Well Name: CORRAL 23-26 FED COM	Well Location: T25S / R29E / SEC 23 / SWNE / 32.117525 / -103.952672	County or Parish/State: EDDY / NM
Well Number: 308H	Type of Well: OIL WELL	Allottee or Tribe Name:
Lease Number: NMNM120895	Unit or CA Name:	Unit or CA Number:
US Well Number: 3001556899	Operator: XTO ENERGY INCORPORATED

Notice of Intent

Type of Action: APD Change

XTO Energy Inc. respectfully requests approval to make the following changes to the approved APD. Changes include KOP, FTP, LTP, BHL, Proposed total depth, Dedicated acreage, Formation TVD, Casing Design, Cementing Program, and Mud circulation system.
APD ID 10400098912; Well API: 30-015-56899

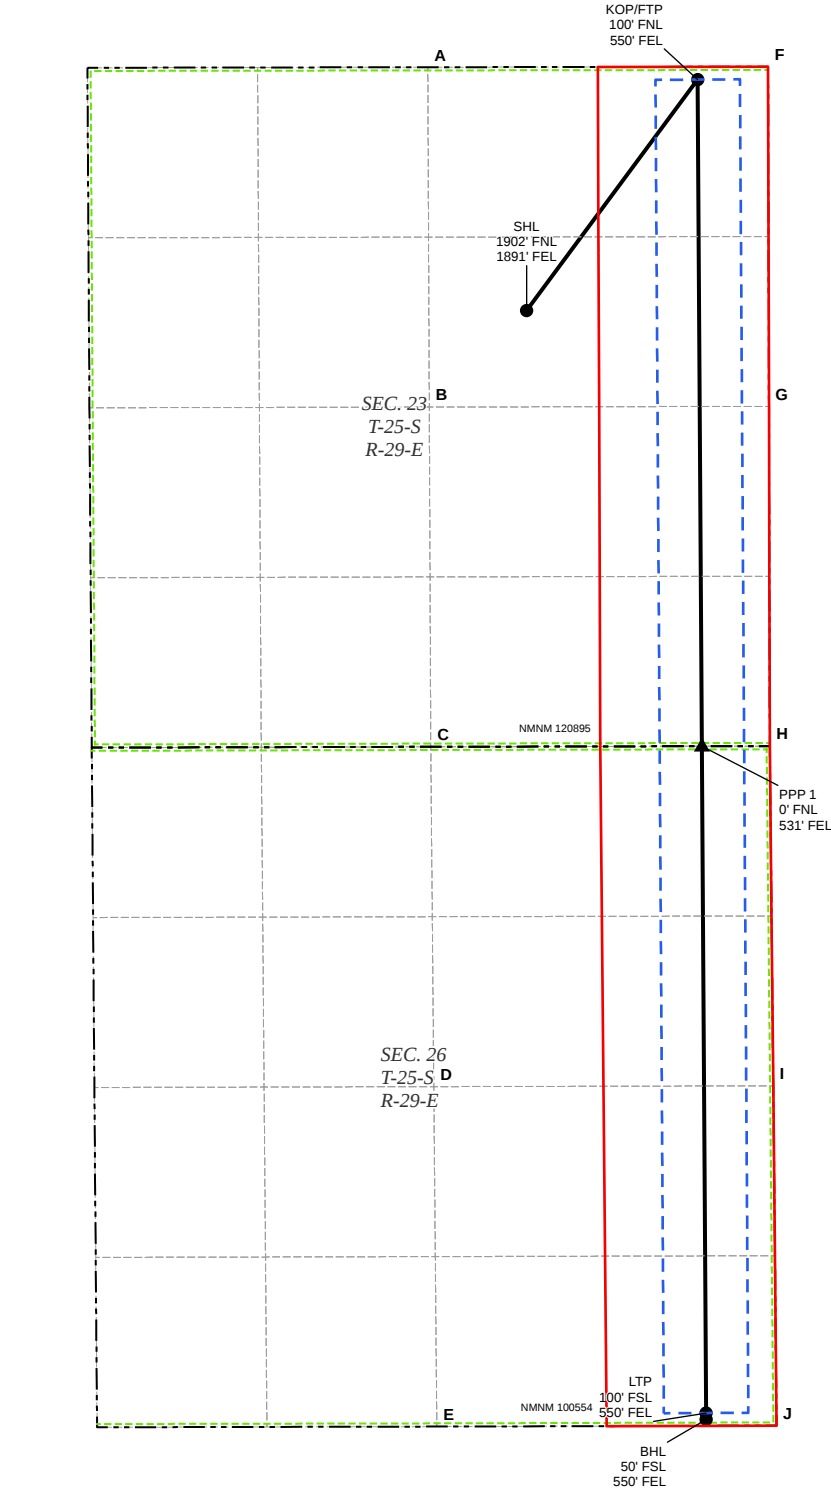
KOP: 1902' FNL & 1890' FEL OF SECTION 23-T25S-R29E 100' FNL & 550' FEL OF SECTION 23-T25S-R29E
FTP: 100' FNL & 660' FEL OF SECTION 23-T25S-R29E 100' FNL & 550' FEL OF SECTION 23-T25S-R29E
LTP: 100' FSL & 660' FEL OF SECTION 35-T25S-R29E 100' FSL & 550' FEL OF SECTION 26-T25S-R29E
BHL: 50' FSL & 660' FEL OF SECTION 35-T25S-R29E 50' FSL & 550' FEL OF SECTION 26-T25S-R29E

The proposed total depth is changing from 25308 MD; 8154 TVD to 19934 MD; 9120 TVD

The Dedicated acreage is changing from 640.00 to 320.
